Applicant's Response to Louth County Council Further Information Request P.A.Ref.2460266

LRD Old Slane Road, Mell/Tullyallen, Drogheda, Co.Louth

Prepared on behalf of
Lagan Homes Tullyallen Ltd

Figure 1: Illustrative example of separation distance between House Type K and L. For further details please refer to JFOC Architectural Design Statement Appendix A under separate cover.

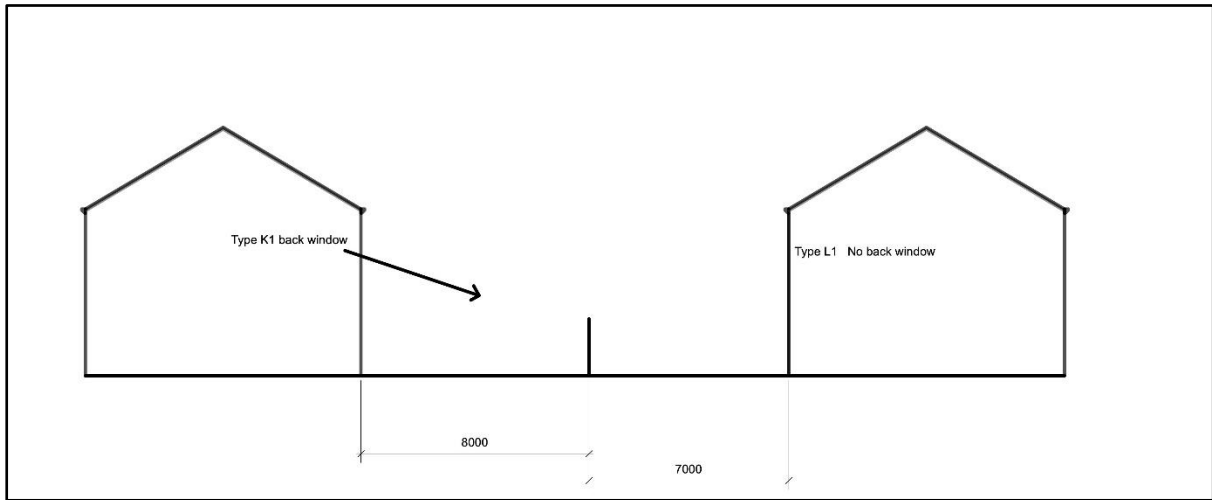
a) The layout of a number of dwellings results in a 14m separation distance between the rear elevations (associated with House Types K1 or K2 and L1). While the Statement of Consistency sets out that there are no first floor opposing windows, the Planning Authority does not consider this to be an appropriate design solution and considers that the first floor windows to the rear elevation of House Types K1 and K2 result in overlooking to the rear gardens associated with House Types L1 which are already limited in size and limit the functionality of the private amenity space. Accordingly, and having regard to SPP1 of the Sustainable Residential Development and Compact Settlement Guidelines, a minimum separation distance of 16m should be provided in order to prevent undue overlooking of private amenity spaces and to ensure a quality and functional area of private amenity space for future residents. The applicant is advised that this is likely to require a reconfiguration of the layout of the development and may require the number of units in the development to be reduced.

SPPR 1 requires a separation distance of at least 16 metres between opposing windows above ground floor level serving habitable rooms at the rear or side of houses. The boundary wall between opposing units would conventionally be centrally located, giving an 8m separation distance from all first floor windows to the boundary wall. The submitted arrangement of House Types K and L does not result in opposing windows at first floor level, and as such the separation distance was reduced to 14m. However, as noted in the F.I. request, as the boundary wall has been centrally located, this arrangement would result in 7m (less than 8m envisaged under the 16m arrangement) from first floor windows to the boundary wall. Accordingly, the separation distance between units has been increased by 1m which provides 8m between the first floor windows on the K types and the boundary wall, whilst retaining the 7m rear garden length for the L types which have no first floor windows.

Figure 12: Bin storage areas for apartments are identified with red text on JFOC drawing nos. 3001, 3004, 3007

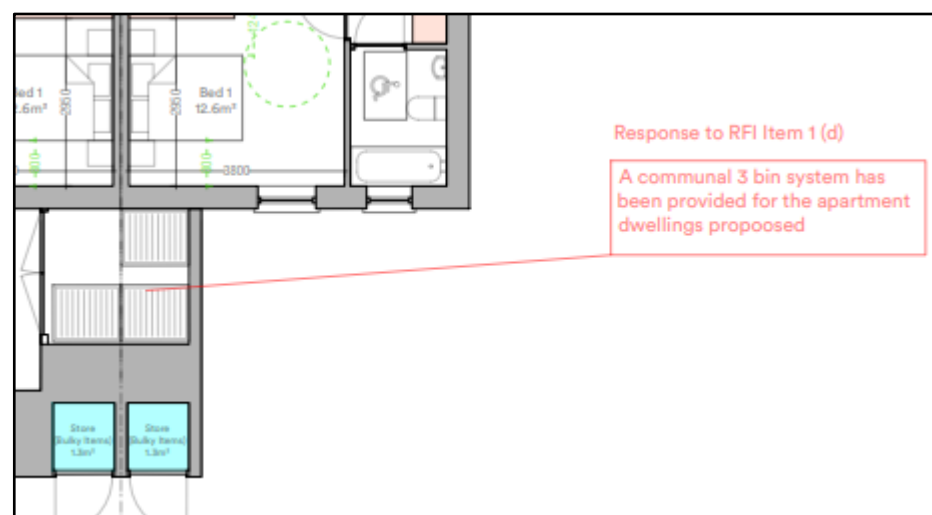
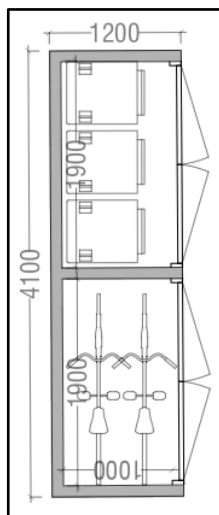
d) The applicant is requested to provide a three-bin system to the bin storage areas of apartments and relevant dwelling units.

JFOC drawing nos. 3001, 3004, 3007 provided under separate cover identify the location of bin storage areas for the apartments. There are six bin stores, two for each block and all are within a short walking distance of the apartments and readily accessible for refuse collection. Each of the bin stores is designed to store 3no. 1100litre bins in order to provide a three-bin system for apartment residents.

Bin storage areas meet with the requirements of the Sustainable Urban Housing: Design Standards for New Apartments (2023) para.4.8-4.9; externally located, ensuring adequate ventilation, and large enough to facilitate the 3-bin system allowing for the segregation of waste into Mixed Residual Waste, Mixed Dry Recyclables, and Organic Waste streams. It will be the responsibility of the apartment occupiers to carry out this segregation of waste at source and to transfer this waste to the communal bin store, where bins will be clearly labelled according to their stream. All mid-terrace dwellings have screened bin storage as identified on the site layout plan and detailed by drawing No. 22.127.PD7003 submitted with the application (Bin and Bicycle Store Type A).

Figure 13: Extract from JFOC Site Layout Plan (No. 22.127.OSR.JF.ZZ.DR.A.0001.S1.P1) with bike/bin store (dashed blue line) and play area (dashed green line) identified

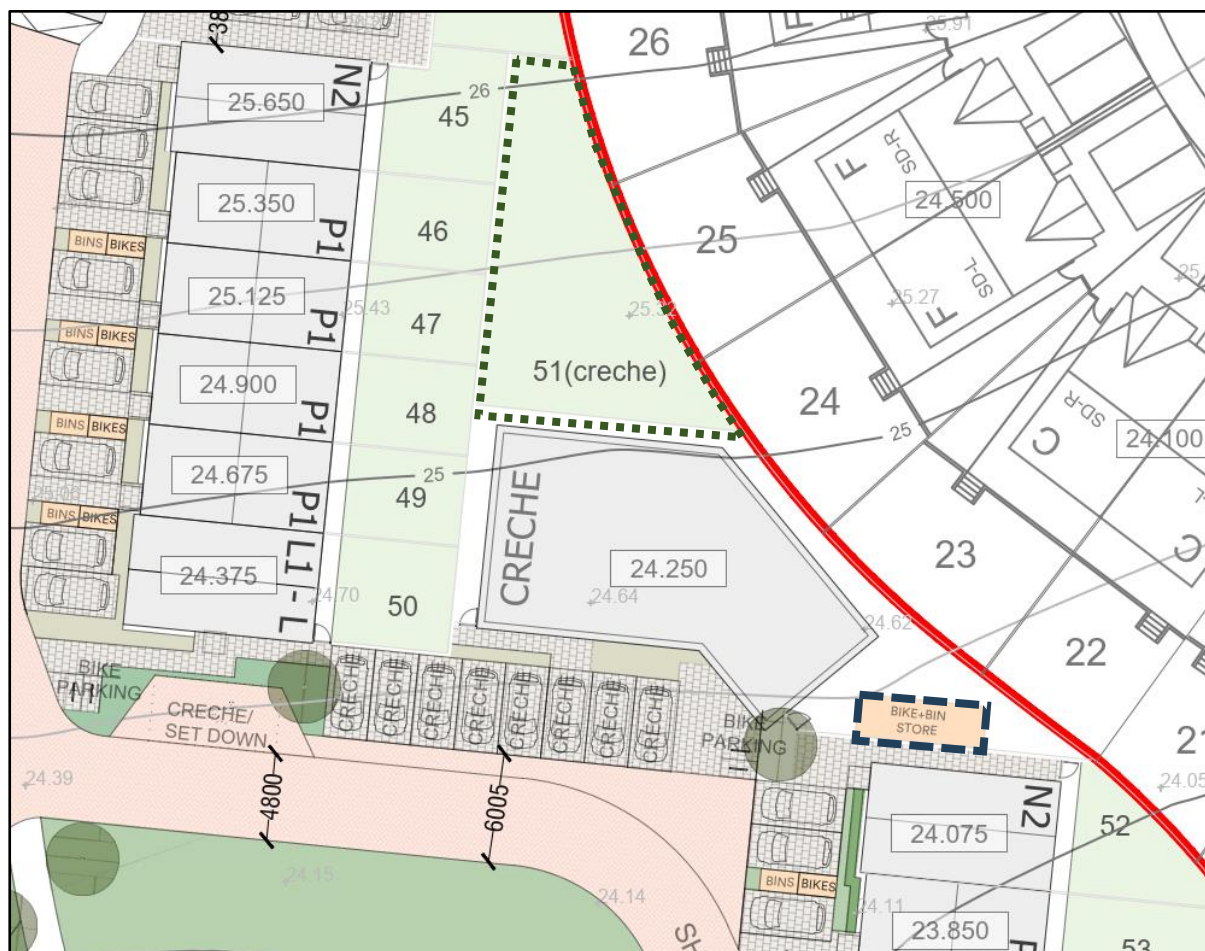
b) In order to ensure that the amenity space associated with the crèche is functional and attractive for future residents, the applicant is requested to demonstrate that the play areas are sufficient in size to cater for the number of childcare spaces to be provided and to illustrate how the play areas will be set out and managed. Please note that the Planning Authority would have concerns in relation to the limited provision of an outdoor play area for the crèche, which would have a capacity of 58 children and would consider that an increased outdoor space would be required in order to make the crèche as functional as possible. In order to provide this additional space, it is likely that the layout of the development will be required to be reconfigured.

The private open space available to the crèche extends to 171m² and exceeds the BRE recommendation for access to sunlight (see section 6.2.1 of IES Report under separate cover). There is no quantitative requirement for outdoor space per child in a childcare facility within the Louth County Development Plan or the Child Care Act 1991 (Early Years Services) Regulations 2016. According to Regulation 20 (1) (a), “having regard to the number of pre-school children attending the service, their respective ages and the amount of time they spend on the premises, there are adequate and suitable facilities for each child to play indoors and, where required by these Regulations, outdoors, during the day”. Outdoor space is required to be “suitable, safe and secure”.

Ultimately it is the end users service policy that will determined how the outdoor space will be used. It is submitted the quantity of space provided is adequate to allow for suitable, safe and secure play in keeping with the Regulations. All boundaries to the rear of the crèche are 2m high block walls. Access to the rear of the property will be controlled with gated entrances to the east and west of the building providing a clear boundary between the public realm and the private crèche for security.

Figure 13: In curtilage EV charging points – for illustrative purpose

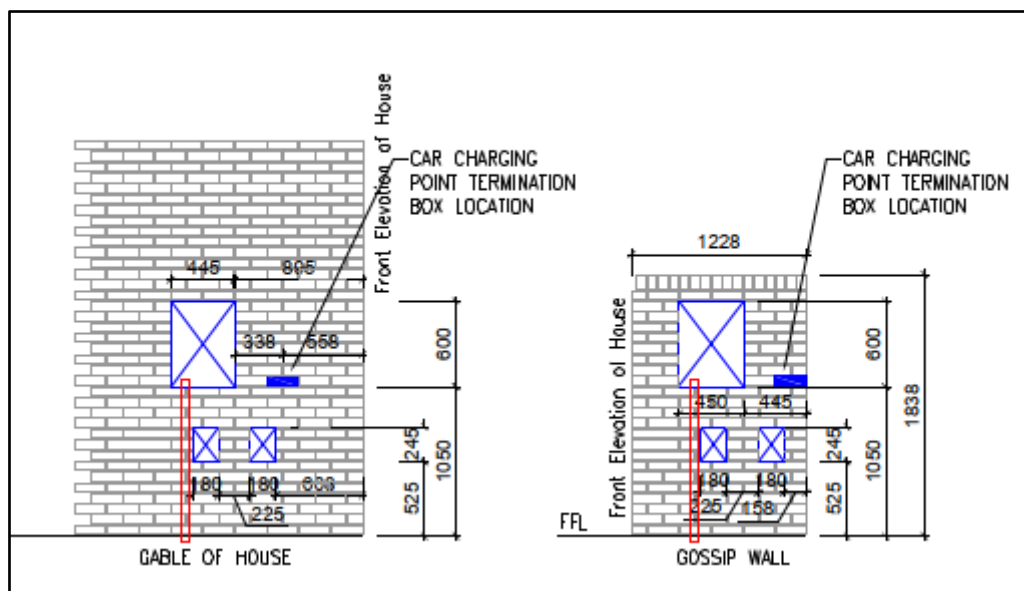
d) Demonstrate charging points will be provided to all dwellings and associated in-curtilage car parking spaces.

Please refer to Waterman Moylan Engineers drawing no. E1001 which detail how charging points will be provided to all dwellings and associated in-curtilage car parking spaces. Gossip walls will be provided for mid-terrace units so that charging points and electric metres can be neatly arranged. The position of gossip walls has been indicated on the site layout plan by JFOC submitted under separate cover. Detached and semi-detached housing will use the gable of the house.
